RE: St. Lucie Unit 1  
Docket No. 50-335  
Proposed License Amendment  
Supplemental Information  
Personnel Airlock Open During Core Alterations

**Proposed License Amendment  
Supplemental Information  
Personnel Airlock Open During Core Alterations**

**Figure 1A A/C Units & Fresh Air Filter Housing**

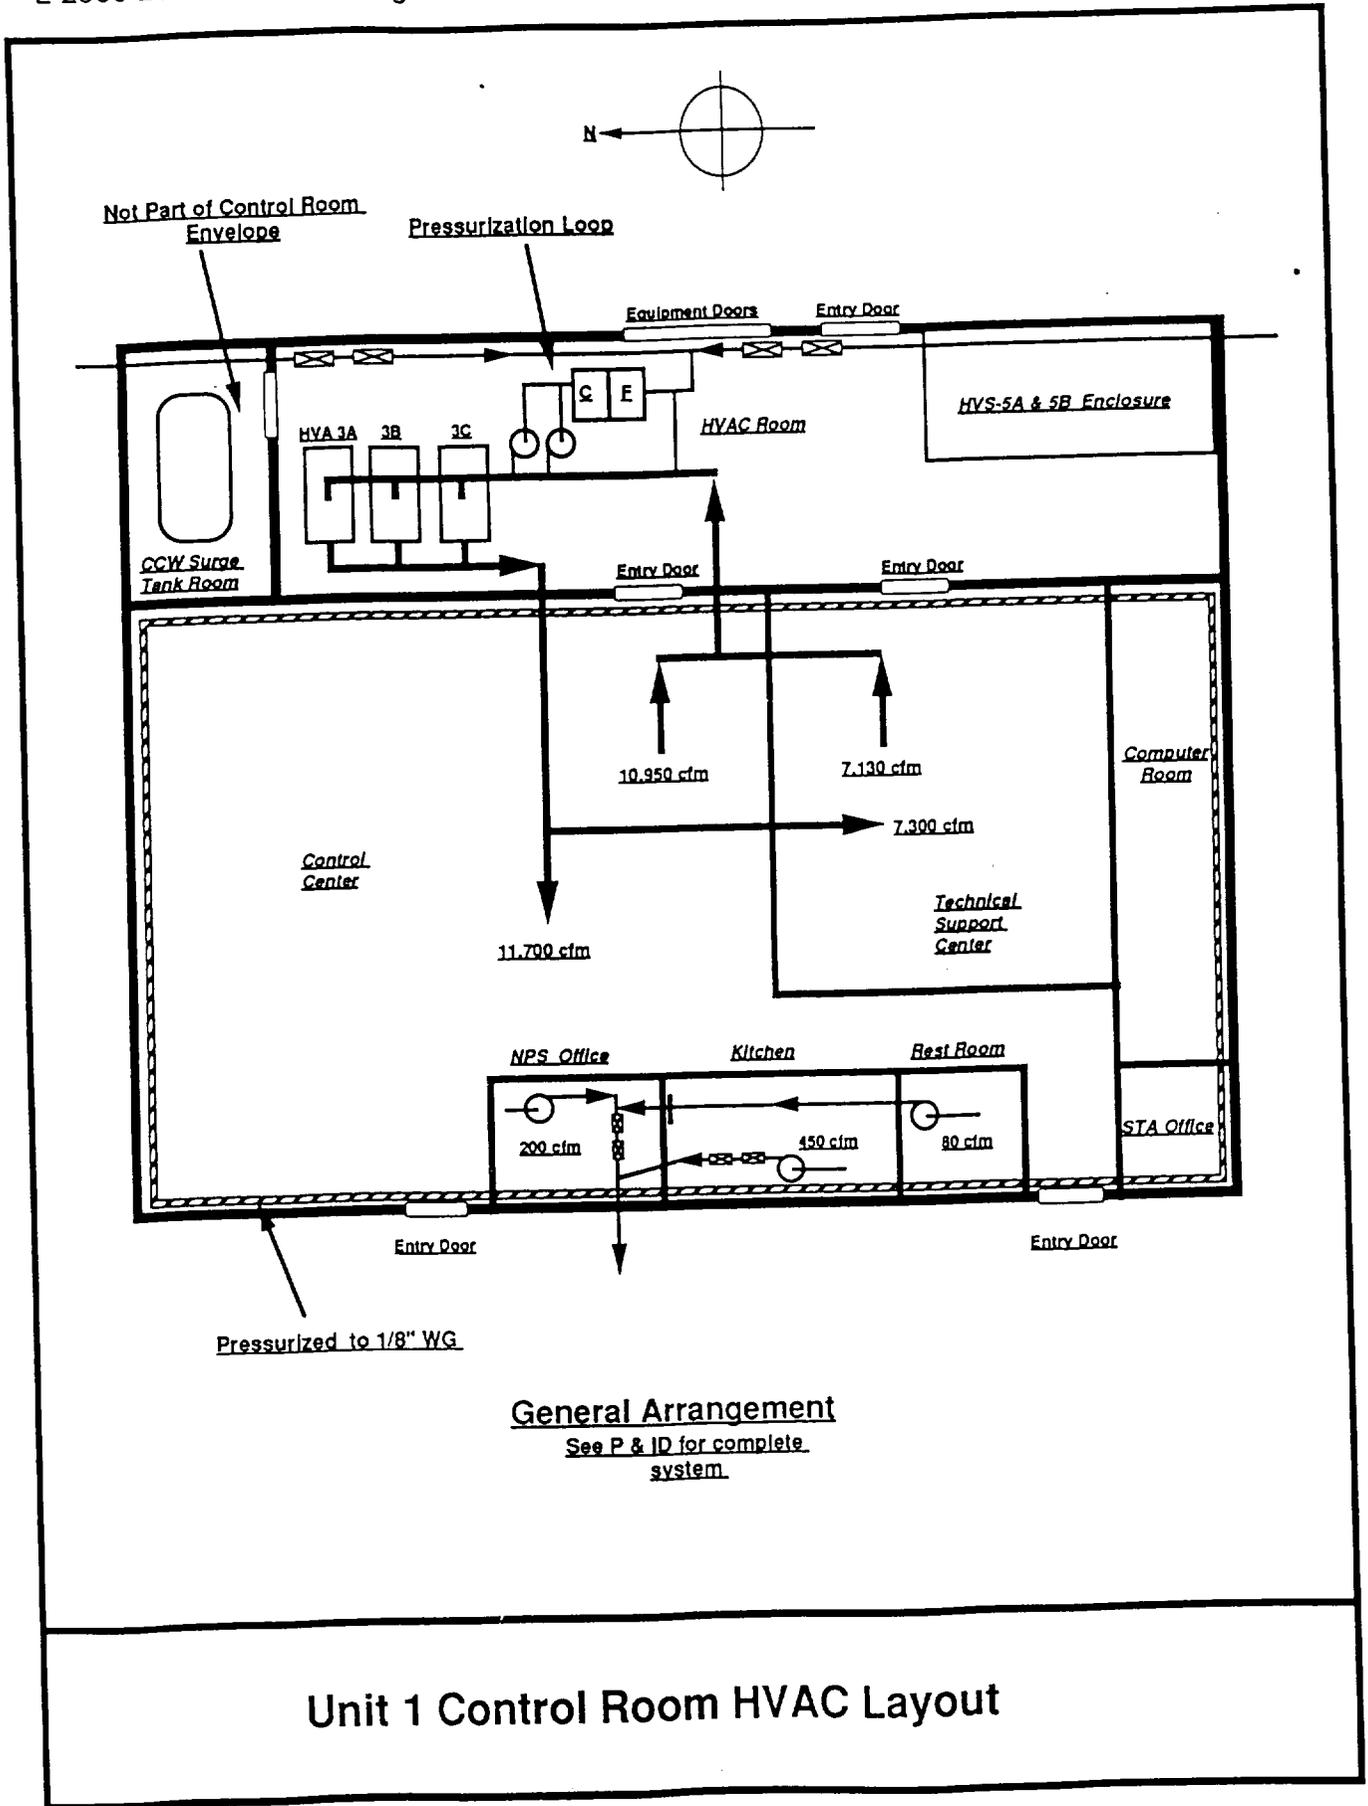
- 2) How are the connections made between the HVAC Duct work and components?

There are both welded and bolted connections. Photos are provided as Figure 1A, 1B, and 1C to show the general arrangement of this system and its connections. These pictures show an air conditioning (A/C) unit, the pressurization filter, and charcoal filter housing. Two views of the pressurization fans and duct work. They are joined to the filter housing directly via a bolted connection.

Figure 3

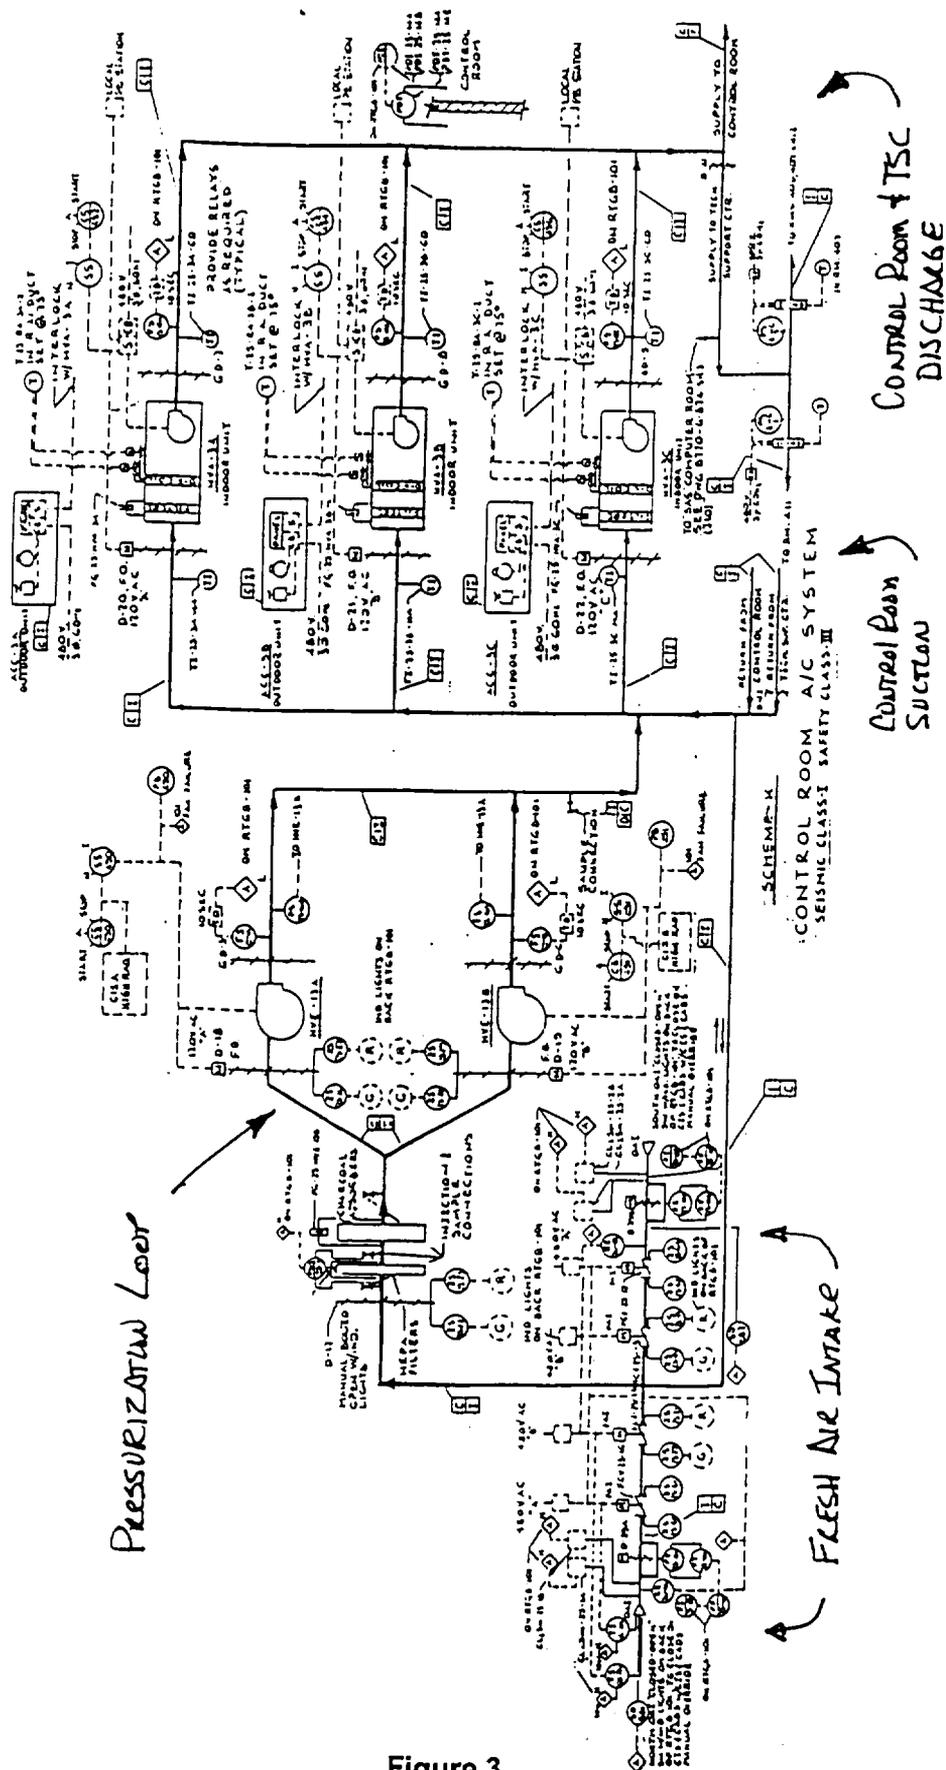
- 1) How many differential pressure (dp) gauges are there for determining differential pressure between the control room and the outside air?

- 3) Provide a simplified control room envelope diagram.

- 4) Verify that no other HVAC ducts penetrate the control room envelope which could provide bypass flow.

There are two dp gauges that are shown on the far right of the P&ID 8770-G-879. These gauges are designated as PDT 25-14A and 14B.

A single line diagram showing the general arrangement of the Unit 1 control room and major HVAC components is provided as Figure 2. Additionally, Figure 3 is an excerpt from the P&ID for the system. This is plant drawing 8770-G-879, Revision 32.

There was no other ductwork identified that is not on the P&ID or the general arrangement drawing provided in response to question 3.
